Comment-Response Document 2017-14

to ED Decision 2019/012/R

RELATED NPA 2017-14 - RMT.0638 - 23.05.2019

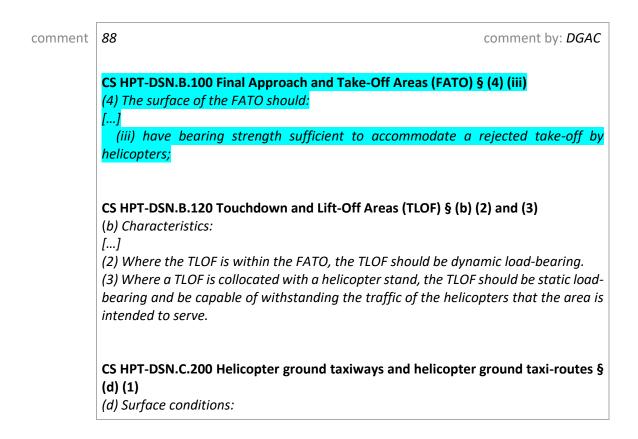
comment	87 comment by: DGAC
	CS HPT-DSN.B.100 Final Approach and Take-Off Areas (FATO) § (a) (2):
	(a) Location:
	[] (2) The FATO should be located so as to minimise the influence of the surrounding environment, including turbulence.
	GM1 HPT-DSN.B.100 Final Approach and Take-Off Areas (FATO) § (a) (2) and table
	GM1-B-1

(a) General:
	[]
	(2) Where a FATO is located near a runway or taxiway, and when simultaneous
	helicopter and aeroplane operations are planned, the separation distance between
	the edge of a runway or taxiway and the edge of a FATO should not be less than the
	appropriate dimension in Table GM1-B-1.

Comment :
	Agreed with the necessity of this CS.
	Regarding the FATO minimum separation table (Table GM1-B-1), from the Annex 14 Volume 2, proposed in GM:
	There is a consensus at the ICAO Heliport Design Working Group about its obsolescence. It should be removed from the Annex.
	A quick assessment highlights the contradiction between this table and the minimum distance separation between runways.

The separation distance between FATO edge and runway edge for light helicopters/aeroplanes is 60m. If we add a runway half-width, even the largest 30m for code F, and for example a 15m FATO half-width + 3m SA, the RWY/FATO centre lines would be separated by 108m. This is inconsistent with the minimum distance between parallel non-instrument runways (CS ADR-DSN.B.050), 120m for runway code 4.

Using code runway 1C values, runway half-width is at the maximum 11.5m + 60m (table GM1-B-1) + 18m (FATO+SA) gives 89.5m separation distance according to CS HPT-DSN. It is still in contradiction with the 120m minimum separation distance sets by CS ADR-DSN.B.050.

The higher values (120/180/250m) given for heavier helicopter can also be inconsistent with the CS ADR-DSN.B.050, not to mention CS ADR-DSN.B.055 for instrument runway.

As a consequence, DGAC proposes to replace this table with a general requirement for a safety assessment at aerodrome level to allow simultaneous operations.

response Not accepted (comment on GM1 HPT-DSN.B.100)

The text and the table are identical to the relevant text and table in ICAO Annex 14, Volume II, Heliports, paragraph 3.1.63, 3.1.64 and Table 3-1, and they are provided as guidance material. The commentator is invited to provide to EASA a proposal for the amendment of CS-HPT-DSN with the explanation and justification to be considered in one of the forthcoming NPAs.
